SUBJECT: IN THE MATTER OF 238 NUCLEAR ISLAND
GENERAL ELECTRIC STANDARD SAFETY ANALYSIS REPORT (GESSAR II)
DOCKET NO. STN 50-447

SUPPLEMENTAL RESPONSE AND PROPOSED RESOLUTION TO DISCUSSION
ITEMS

SUPPLEMENTAL RESPONSE TO
INSTRUMENTATION AND CONTROL SYSTEMS BRANCH
QUESTION ON MANUAL INITIATION OF SAFETY SYSTEMS

421.32 RESPONSE SUPPLEMENT

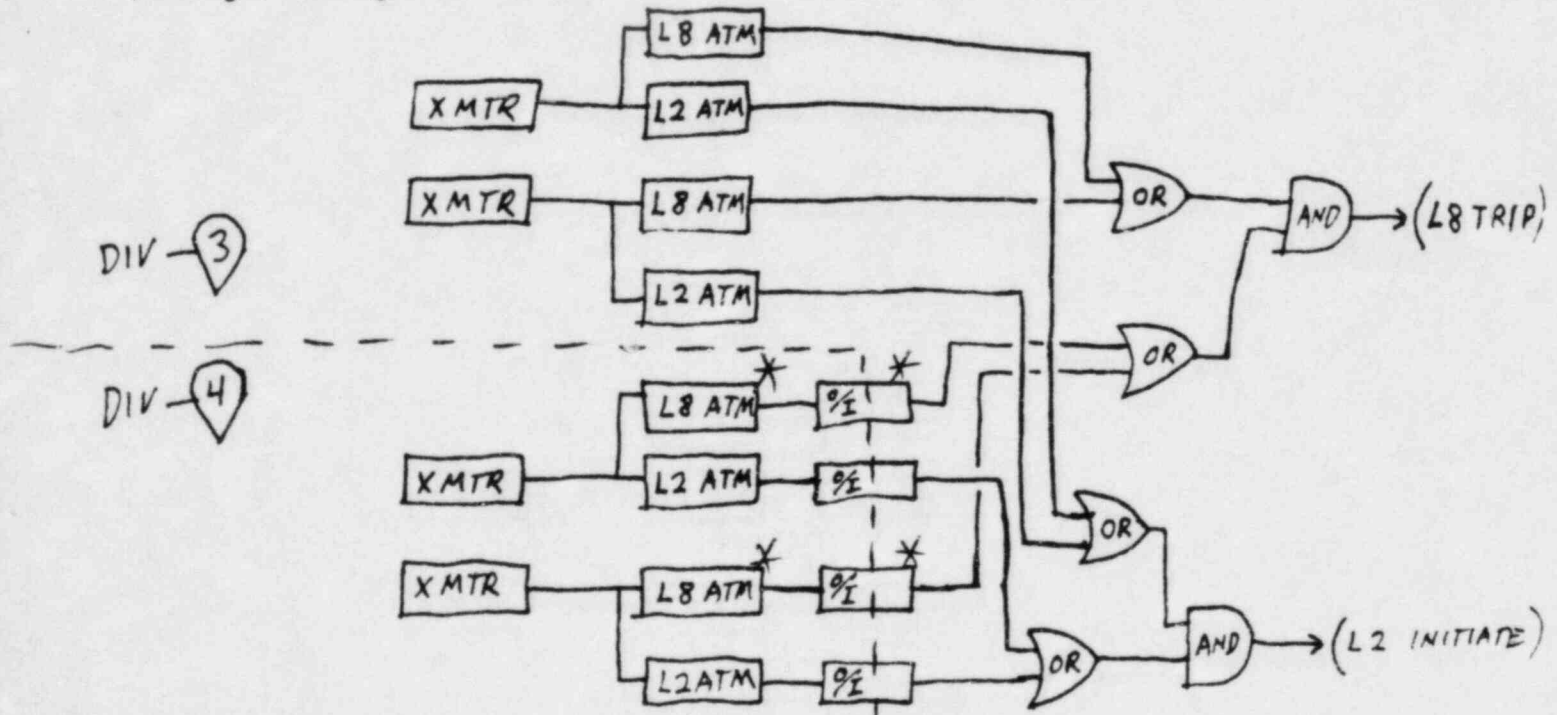
(Change HPCS description only per attached)

The HPCS subsystem is initiated automatically by a LOCA signal (low reactor water level in a 1-out-of-2-twice logic arrangement or high drywell pressure in 1-out-of-2-twice logic) or manually by a system level armed pushbutton. In addition, the subsystem can be placed in operation by use of an individual remote manual switch for each valve and the pump. In all three initiation modes, the injection valve is interlocked closed by high water level (level 8) in a ~~1-out-of-2~~ ^{2-out-of-2} logic arrangement. If the valve is open, high water level (level 8) will cause it to close.

The level 8 signal is provided by ^{*}four analog trip modules (ATM's) which are paired with four separate transmitters. These four transmitters also provide the four inputs used in the 1-out-of-2-twice, low-water-level system initiation circuit. The following sketch illustrates the above explanation:

The four level 8 ATM's provide the common interlock for injection valve opening in the automatic initiation mode and the two manual initiation modes.
